Statistical Setpoint/Transient Methodology for Combustion Engineering Type Reactors

SUBJECT: ACCEPTANCE FOR REFERENCING OF LICENSING TOPICAL REPORT EMF-1961(P), REVISION 0, "STATISTICAL SETPOINT/TRANSIENT METHODOLOGY FOR COMBUSTION ENGINEERING TYPE REACTORS" (TAC NO. MA4659)

GENERAL QUESTIONS PERTAINING TO BOTH THE WESTINGHOUSE AND COMBUSTION ENGINEERING STATISTICAL SETPOINT/TRANSIENT METHODOLOGY

Responses to General Questions pertaining to both the Westinghouse and Combustion Engineering Statistical Setpoint/Transient Methodologies

Figure 2.1 Flow of LPD LSSS or LCO Confirmation

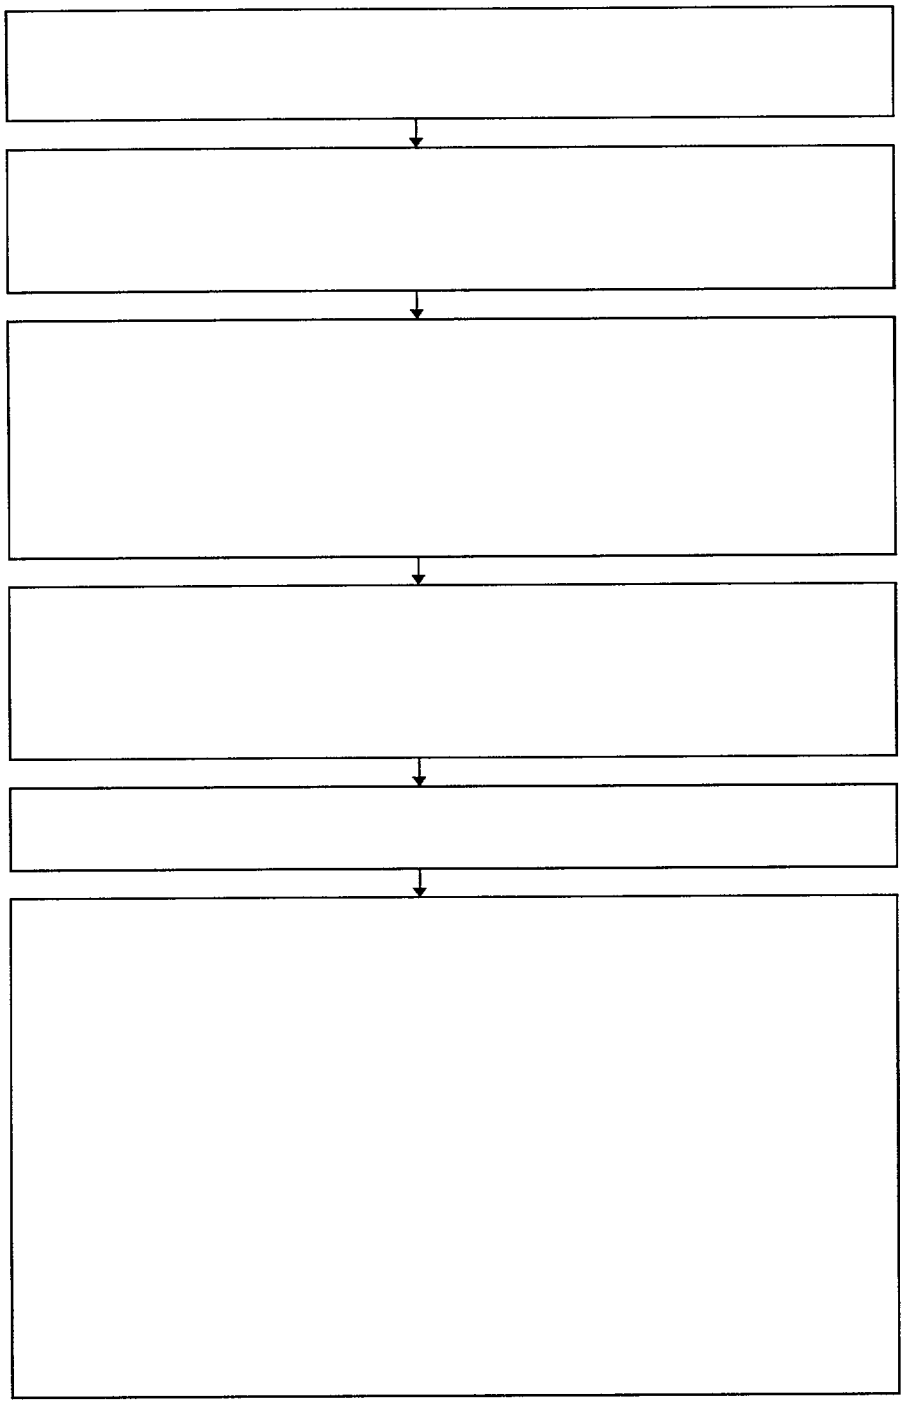
1. Please provide flowcharts of overall methodology for arriving at the statistical setpoint/transient analysis.

Figure 2.1 shows the flow of the process for confirming the LPD LSSS. To confirm the LPD LSSS, a series of calculations is performed using each axial power shape. Those shapes for which the melt power exceeds the power at which the shape was

Figure 2.2 Flow of TM/LP Confirmation

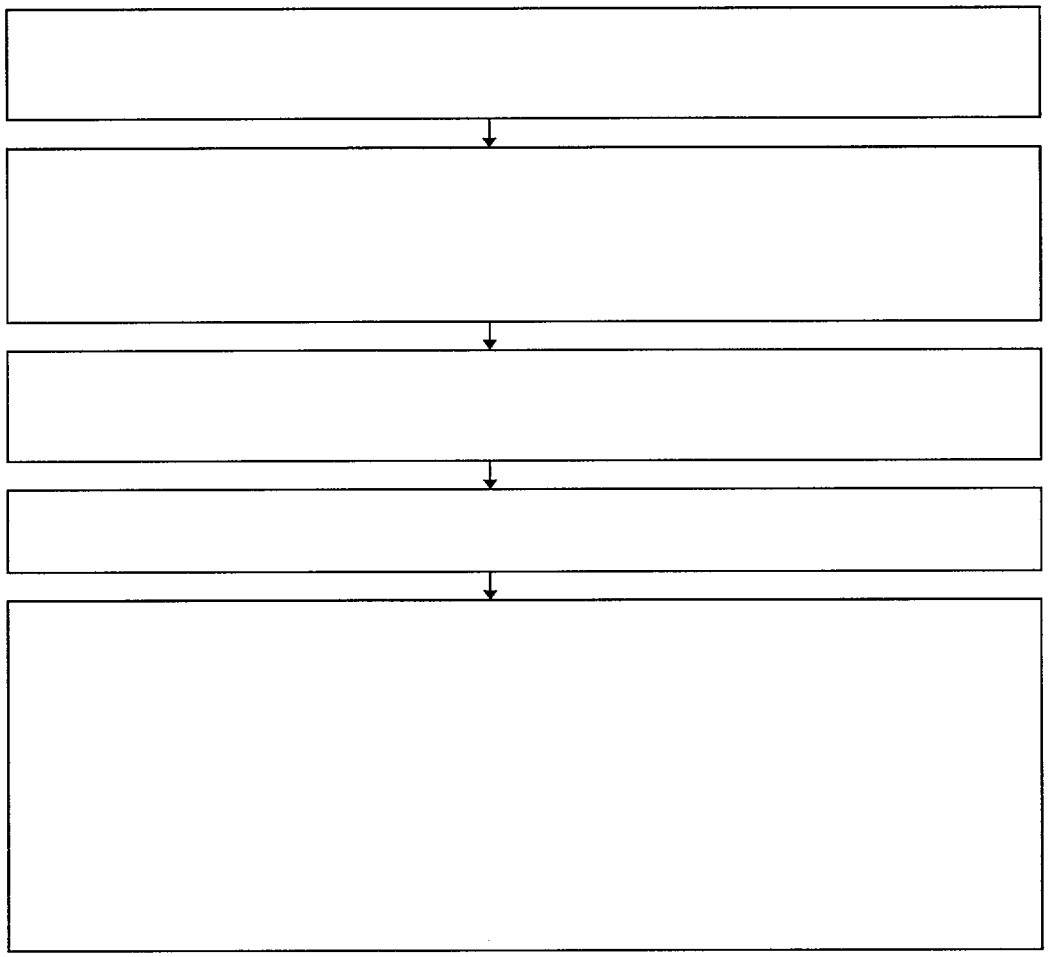
The general form of the TM/LP trip is given. Please detail how the alpha, beta, and gamma terms for the equation were determined.

The iterative scheme for obtaining the DNB portion of the P_{VAR} is described. Please provide additional details or a demonstration of this iterative scheme.

The coefficients for the TM/LP trip; α, β and γ; are determined such that they prevent the occurrence of hot leg saturation or DNB. The traditional method of determining the values makes use of the Core Safety Limit Lines (CSLLs) and finds a set that conservatively bounds the CSLLs. When a confirmation of the trip is performed, the values selected for the trip are checked to confirm that they provide the protection for DNB and hot leg saturation. Whether SPC created the values from the CSLLs or modified existing values in some way, the ultimate test of the acceptability of the values is the confirmation process.

The iterative process seeks to determine the pressure at which DNB would occur. When uncertainties are ignored, DNB occurs at the mean value of the correlation [ ] The iterative process is repeated for a range of values in power and T_{inlet} that cover the range over which the TM/LP would need to provide protection. In addition to the power and T_{inlet}, the axial power shape is considered as a variable, too. These three inputs are varied because they represent the parameters that are input to the TM/LP.
